Technical Bulletin

NRV LR UPDATE

Document reference number **TB/107/0516**

fig.3 Wiring and tube connnection details.

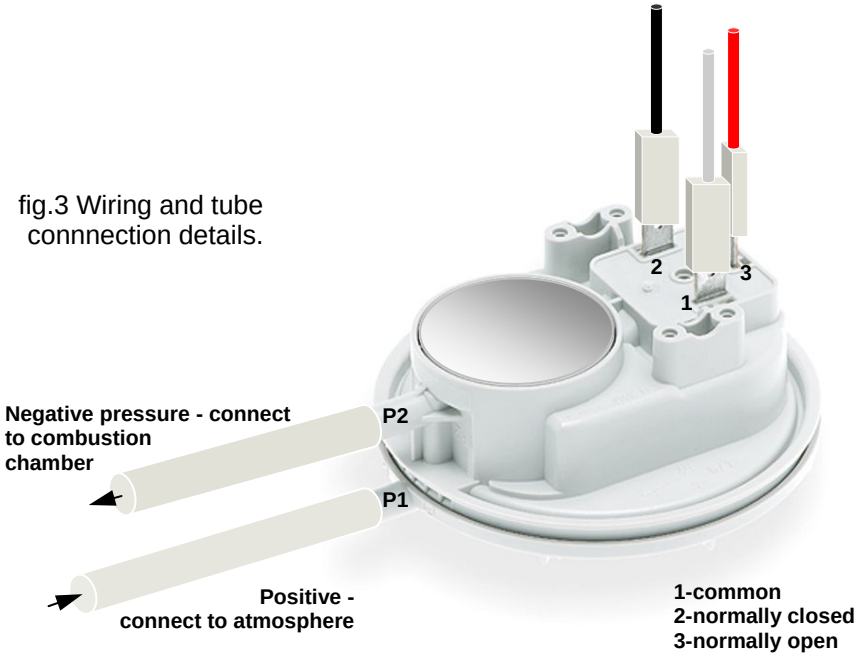
Air pressure switch changed from part no. L104039 (orange identification label) to part no. 202861 (grey identification label).

fig.1. Original pressure switch part no. L104039

fig.2. Replacement pressure switch part no. 202861
